Application for Works Approval

Works Approval Number	W6672/2022/1
Applicant	Newcam Minerals Pty Ltd
ACN	30 627 911 997
File number	DER2021/000727
Premises	Mt Gould Iron Ore Project Legal description - Mining Tenement M52/236 Landor – Meekatharra Road PEAK HILL WA 6642 As defined by the premises map attached to the issued works approval
Date of report	7 July 2022
Decision	Works approval granted

Figure 2: Stormwater Management Infrastructure at the Premises

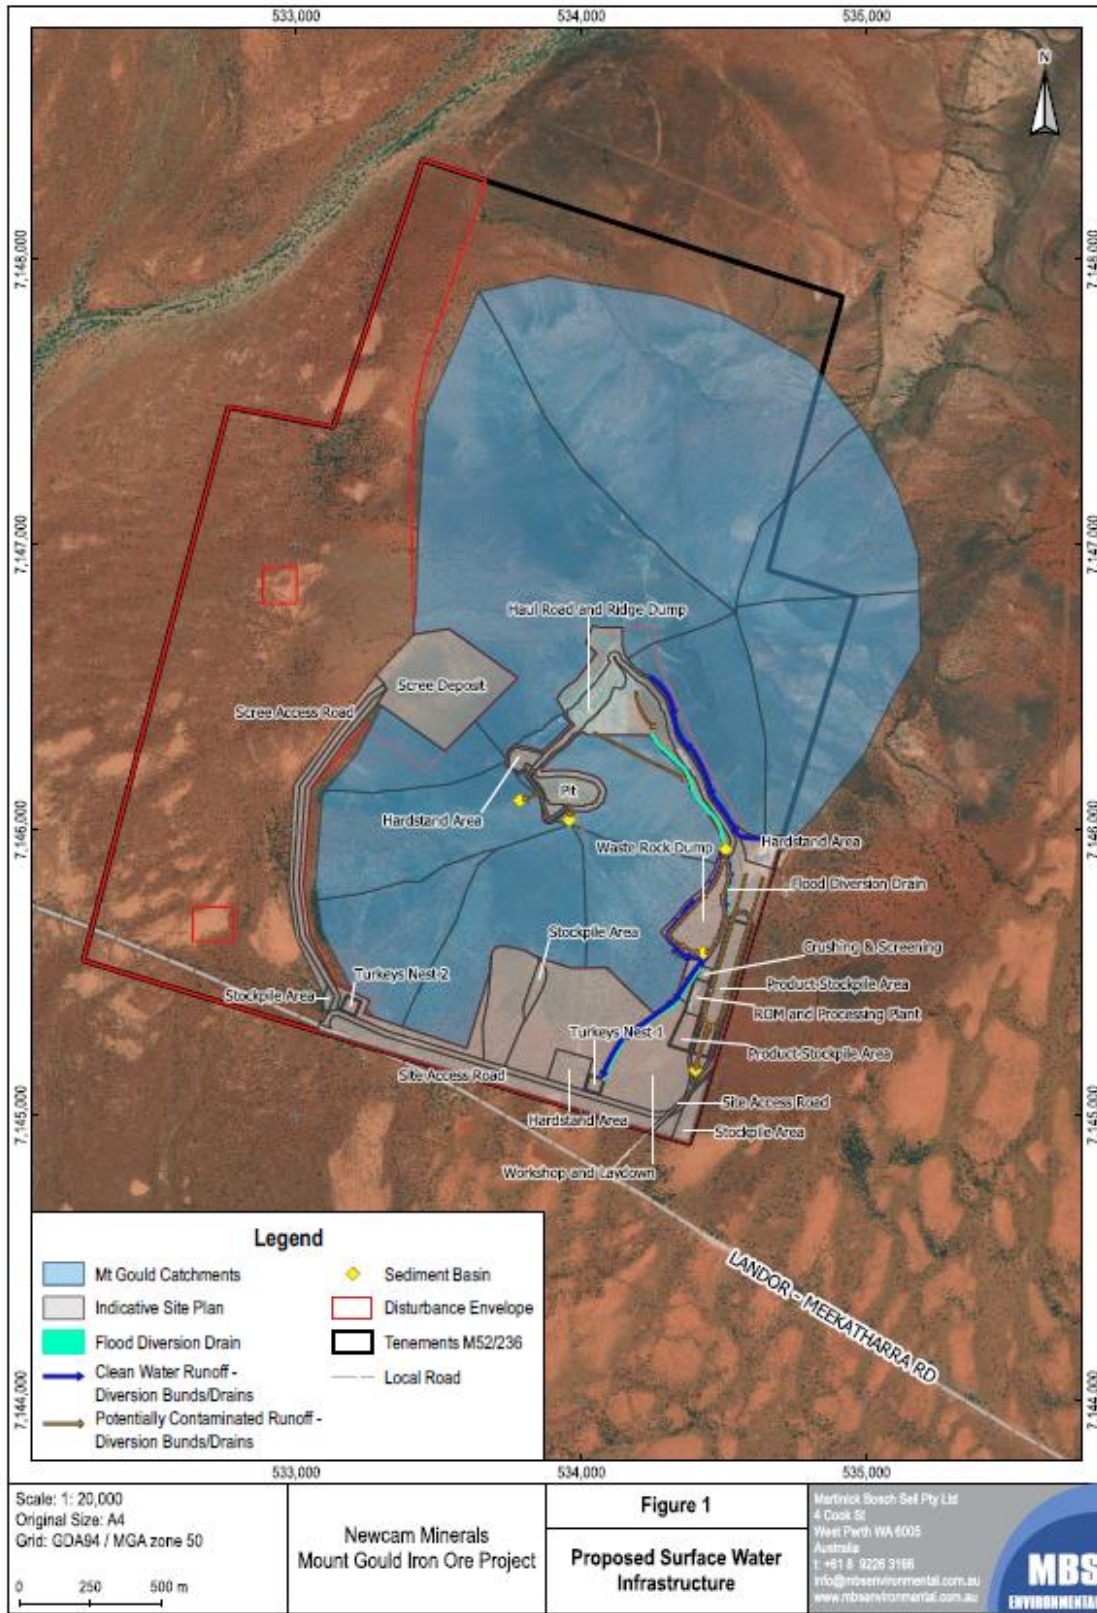
Condition	Summary of applicant's comment	Department's response
<p>Decision Report: Proposed Applicant's controls for Sediment laden stormwater</p> <p>DWER requested the Applicant advise of the dimensions of the sediment basins located on site. Applicant to advise storage capacity of the basins and the Annual Exceedance Probability (AEP) percentage).</p> <p>DWER requested the Applicant to advise if inspections of sediment basins will be conducted to ensure its integrity (particularly following large rainfall events) and if so the frequency of inspections.</p>	<p>Construction / installation requirements for Stormwater Management Infrastructure of the Works Approval have been provided from the Applicant for the Decision Report.</p>	<p>regarding the stormwater management infrastructure that will be constructed and implemented to manage sediment stormwater laden at the Premises.</p>
<p>Section 3.1.1 (Table 1) of the Decision Report: Proposed Applicant's controls for Spills / leaks of hydrocarbons.</p> <p>The Applicant had noted that incident investigation will be undertaken as required to determine the cause of environmentally harmful spills/leaks and control measures identified to prevent future incidents. DWER advised that noting the presence of nearby receptors, the Applicant is to provide more detail on what incident investigation for determining cause of spills/leaks will entail and the</p>	<p>The Applicant provided the following additional management measures to minimise the risk of potential hydrocarbon/chemical spills occurring at the Premises:</p> <ul style="list-style-type: none"> • Daily pre-start vehicle checks will be undertaken on vehicles and heavy Machinery; • Vehicles and heavy machinery will undergo regular maintenance; • Refuelling activities will be undertaken at the designated re-fuelling facility. Any re-fuelling required in the field will utilise drip trays; • Any spill response will be undertaken in accordance with standard spill procedures (Control, Contain, Clean Up); • Spill kits will be available in each vehicle/machinery and be located in strategic locations around site; • Spills will be reported to the site supervisor and logged in the HSE incident system; • Significant spill incidents will be inspected and investigated, with the 	<p>Noted and updated Section 3.1.1 (Table 1) of the Decision Report to include the Applicant's additional proposed controls for managing spills/leaks of chemicals and hydrocarbon's.</p> <p>Condition 11 (Table 4), Item 3: Stormwater Management Infrastructure of the Works Approval has been updated to specify the frequency of inspections and removal of sediment to be weekly and following rainfall events.</p>
